ERRATA - Half-Track - MODELIK 13/10

Rys.15

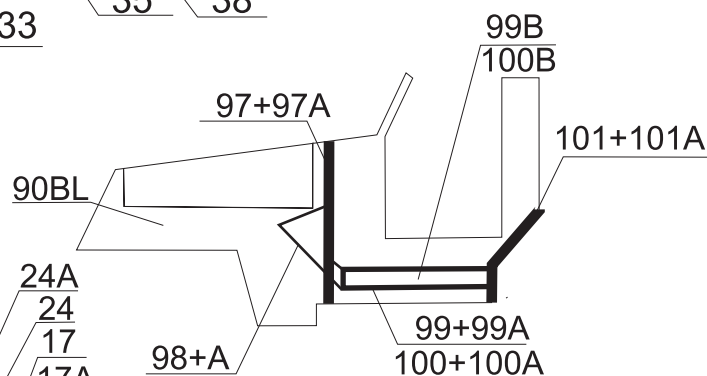
The engine block is not parallel to the frame plane. Engine should be glued in such a way that the top edge of part 42 coincides with the edges of the frames 1L and 1P. By using of 2 mm diameter electric conductor make connections between part 19 on the engine body and the upper surface of the radiator, and between the engine block and bottom surface of the radiator (marked with thick black lines in the figure 15).

Blok silnika nie jest równoległy z płaszczyzną ramy. Silnik powinien być wklejony w taki sposób, aby górna krawędź cz.42 pokrywała się z krawędziami ramy 1L i 1P. Z osłon przewodu elektrycznego o średnicy 2 mm wykonać połączenia pomiędzy cz.19 na korpusie silnika i górną krawędzią chłodnic, oraz pomiędzy blokiem silnika a dolną powierzchnią chłodnicy (na rys.15 grube czarne linie)
